**Re: Request for Council's Advice on SSD-65729209 – 40 The Retreat, Bradfield**

## Attachment A – Detailed comments

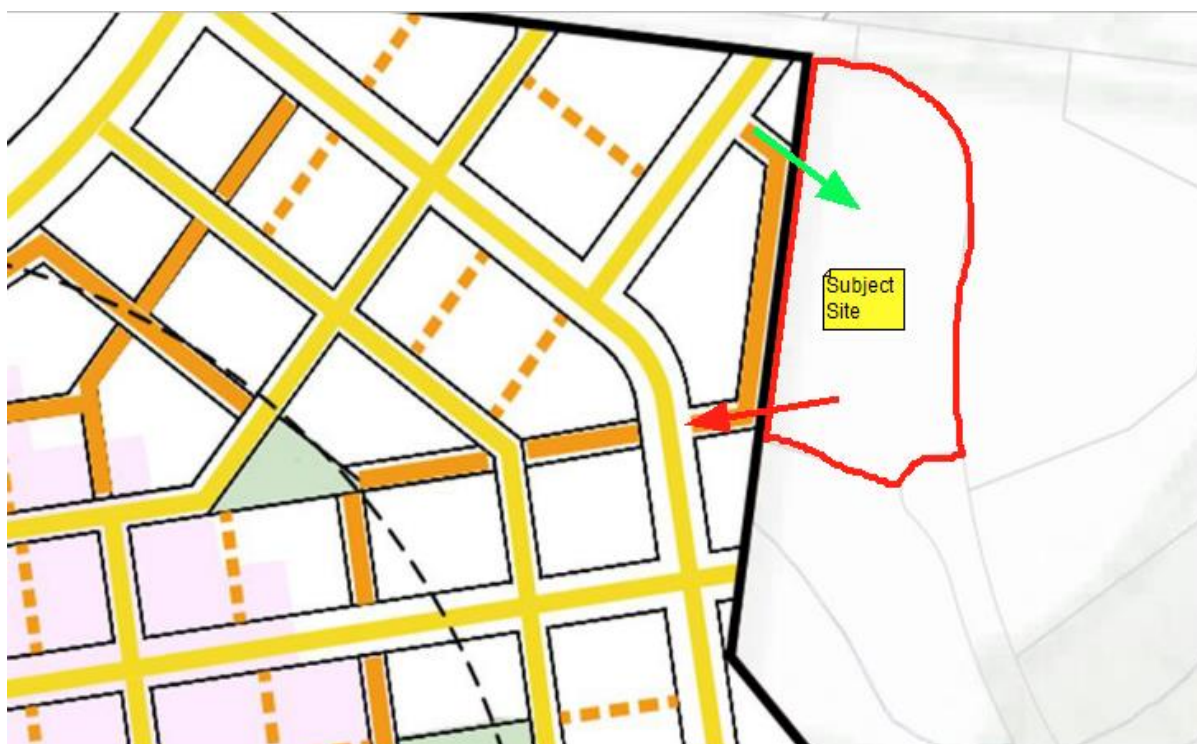
This approach is not supported as neither The Retreat or Kelvin Park Drive provide road reserve designs in accordance with the requirements of the WSAPP and are incapable of providing appropriate pedestrian, active transport and public transport access. As noted elsewhere, both roads are also located in a second priority area and as such, the delivery of WSAPP compliant roads is uncertain. As such, it is recommended that the proponent liaises with both DPHI and BDA in relation to the provision of road infrastructure necessary to service the site in accordance with the Figure 12: Street Hierarchy under the WSAPP (September 2024), see excerpt identifying the site below:

It is noted that Section 9.1 of the Bradfield City Centre Masterplan specifies that a pedestrian priority shared City Lane fronts the western boundary of the site , see excerpt below:

It is recommended that permanent vehicular access and egress be provided in a one-way motion to this city lane as indicated by the notation in the above image.

Figure 1: Bradfield City Town Centre and proposed development 40 The Retreat (Appendix LL)

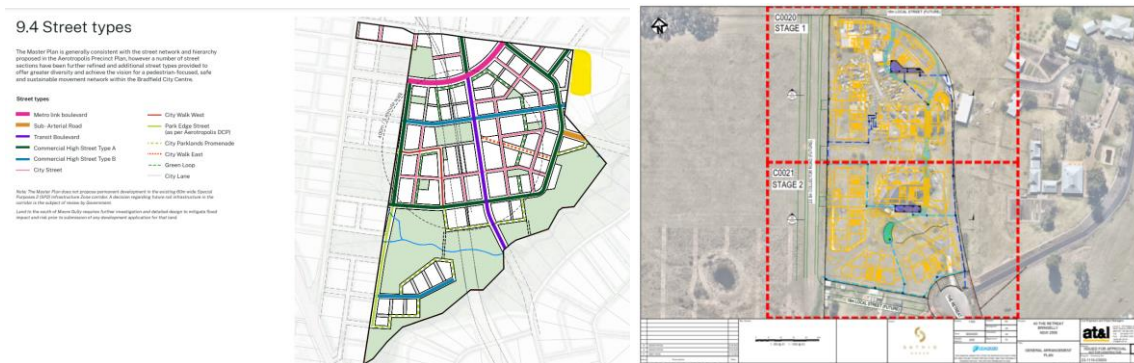
The subject site is adjacent to the proposed road network in the [Bradfield City Centre Master Plan](#) (approved September 2024) and [Western Sydney Aerotropolis Precinct Plan](#) (amended September 2024). It appears the proposed development changes the street layout of adjacent Bradfield City Town Centre (Figure 1).

Road network design for the proposed development is to show the proposed connection to the planned road network in Kelvin Park Drive Precinct to the east.

Consultation is required with adjacent landowners for proposed changes to the road network.
